Well Name: BENSON SHUGART	Well Location: T18S / R31E / SEC 30 / NWSW /	County or Parish/State: EDDY / NM
Well Number: 29	Type of Well: OIL WELL	Allottee or Tribe Name:
Lease Number: NMLC029387D	Unit or CA Name: BENSON SHUGART WATERFLOOD	Unit or CA Number: NMNM88499X
US Well Number: 3001505649	Well Status: Oil Well Shut In	Operator: CHEVRON USA INCORPORATED

Notice of Intent

Type of Action: Plug and Abandonment

Benson Shugart Water Flood Unit 29**API:** 30-015-05649**Fresh Water Depth:** 200'**Potash Area:** No**Notes:**

PROPOSED WELLBORE DIAGRAM

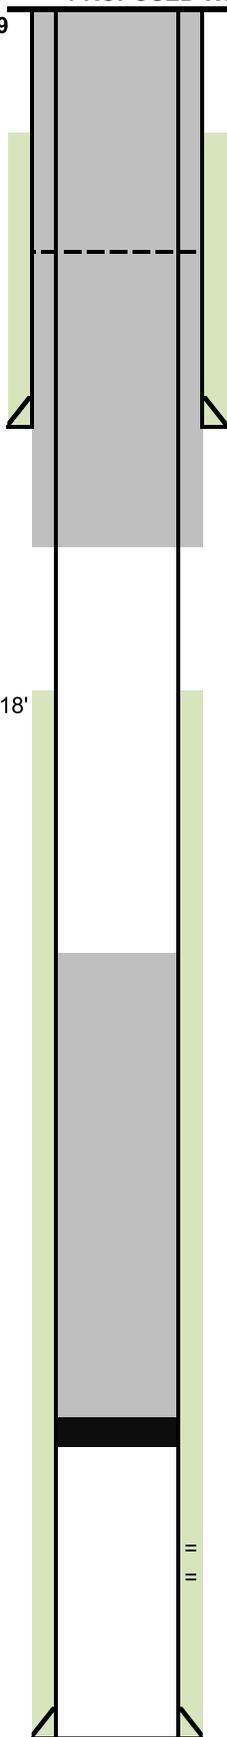
**Surface TOC est:
600'.**

Remove production casing at depth > 100' to perf and sqz against surface casing. Perf and sqz 46sx against surface casing at 100'+ and circulate cement to surface both inside casing(26sx) and annulus(20sx)

Perf & Squeeze or Perf & Circulate 118 sx Class C f/ ~~850' - 350'~~
890-390'

Leak Test. 70sx, 2413' to 1760'. WOC and Tag. Including base of salt
